Access Compliance Report

Public Rights-of-Way

(Curb Ramps)

Intersection ID: N/A	Main Street: MCCLINTOCK_RD	Cross Street: N/A	Location: NW
ADA ID: 75DFA2C8D3E6	Ramp Type: Perp	Initial Pass/Fail: Fail	Overall Compliance: No
Severity Score: 13.75			
Codes/Mitigation Info/Possible Solution		Field Measurements/Component Compliance

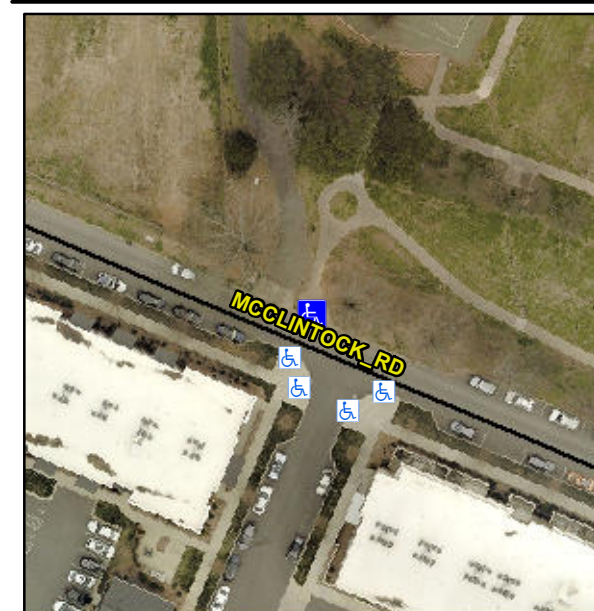
Not Found, R304.2.2, R304.5.3

Compliance	Description	Data	Compliance	Description	Data
N/A	Ramp Length (in)	70.5	No	Ramp Slope (%)	11.7
Yes	Ramp Width (in)	49.5	No	Ramp XSlope (%)	3.7
N/A	Flare Type LT	N/A	N/A	Flare Type RT	N/A
N/A	Flare Slope LT (%)	N/A	N/A	Flare Slope RT (%)	N/A
N/A	Flare Traversable LT?	N/A	N/A	Flare Traversable RT?	N/A
N/A	Landing Length (in)	N/A	N/A	DWS Provided?	N/A
N/A	Landing Width (in)	N/A	N/A	DWS Contrast?	N/A
N/A	Landing Slope (%)	N/A	N/A	DWS Length (in)	N/A
N/A	Landing X Slope (%)	N/A	N/A	DWS Full Width?	N/A
N/A	Landing Curb? (Y/N)	N/A	N/A	DWS Offset (in)	N/A
N/A	Shared Landing?	N/A			
N/A	Gutter Ponding?	N/A	N/A	Gutter Slope (%)	N/A
N/A	Gutter Lip Ht (in)	N/A	N/A	Gutter X Slope (%)	N/A
N/A	Painted X Walk1?	No	N/A	Painted X Walk2?	N/A
	X Walk 1 Direction	To S		X Walk 2 Direction	N/A
N/A	X Walk 1 Width (in)	N/A	N/A	X Walk 2 Width (in)	N/A
	X Walk 1 Slope (%)	5.2		X Walk 2 Slope (%)	N/A
	X Walk 1 X Slope (%)	2.1		X Walk 2 X Slope (%)	N/A

Remove & Replace Entire Ramp.
